APPENDIX F3: COMMENTS & RESPONSE TABLE

THE PROPOSED DEVELOPMENT OF A FREE-RANGE POULTRY BROILER FACILITY ON THE REMAINDER OF FARM NUMBER 563, 564, 565 AND THE FARM KLEINFONTEIN NUMBER 954, WORCESTER, WESTERN CAPE.

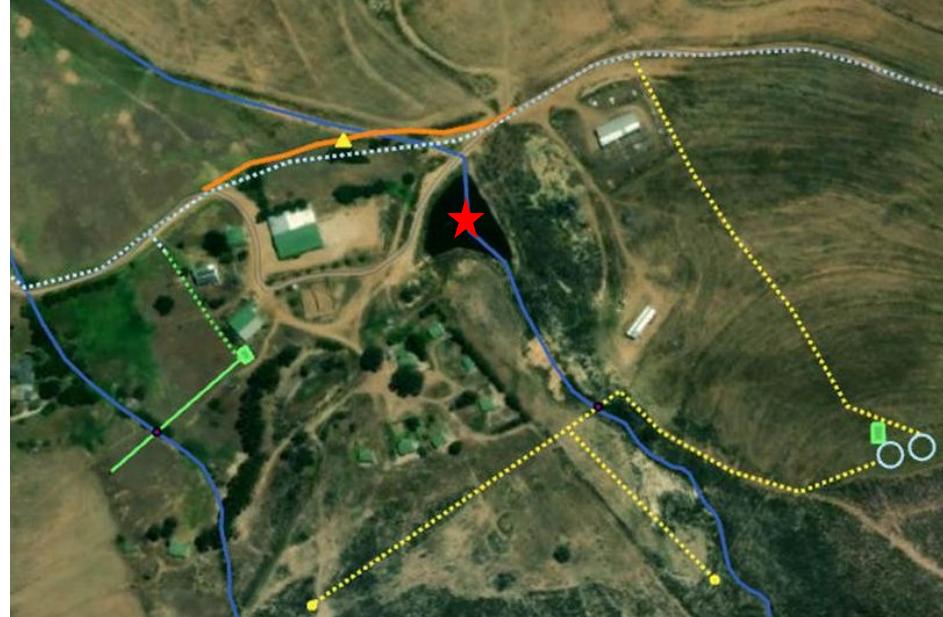
8.3	<p>4. Furthermore, the DBAR indicates that “Four watercourse crossings are required, two are existing crossings and two are new crossings within the proposed road alignment. Three of the structures proposed will be low waterway bridges and one will be a suspended bridge structure. Low waterway bridges are reinforced concrete structures with a driving surface (final top level) raised above ground (natural ground level) and these structures cross waterways nearly perpendicular to the natural water flow direction of the stream. Pipes will be installed at set intervals across the bridge length to allow water to freely pass through. Suspended bridges are reinforced concrete structures with a driving surface (final top level) raised above ground (natural ground level). The structure crosses the waterway at a skew angle to align with the approach roadway alignment. Where the natural runoff channel is deep and narrow a</p>	<p>The Engineer has confirmed that the existing dam above the proposed suspended bridge can be utilised (as indicated by the red star in Figure D below). Therefore, no new additional coffer facility is going to be needed. The engineering report in Appendix G5 was updated to reflect this. As stipulated by the Freshwater specialist “construction activities directly involving freshwater features should preferably be scheduled during the dry summer months—typically from December to March—when rainfall and runoff are at their lowest”. The existing upstream dam will be seen as the ‘coffer facility’ which naturally acts to divert stream water away from the wet works during construction. Considering works is proposed in summer months this would be the natural state of the existing Dam and no new intervention/ structures would be required. Therefore, there will be no additional impacts on the Freshwater Ecosystems as this Dam already captures water from the stream.</p> <p>Jenna Theron – PHS (EAP)</p>

<p>suspended bridge will span across. As there is not enough space at the suspended bridge to divert stream flow to accommodate wet works, a temporary upstream coffer dam must be constructed to temporarily divert stream water away from the wet works during construction.” Please can you indicate on the map or Site Development Plan (Appendix B1a) where this coffer dam will be located and also indicate the potential impacts of this temporary coffer dam on the surrounding Freshwater ecosystems (Streams and wetland areas).</p>	 <p>Figure D: The existing Dam (red star) will be utilised to act as the ‘coffer facility’ during the construction of the suspended bridge at the yellow triangle.</p>
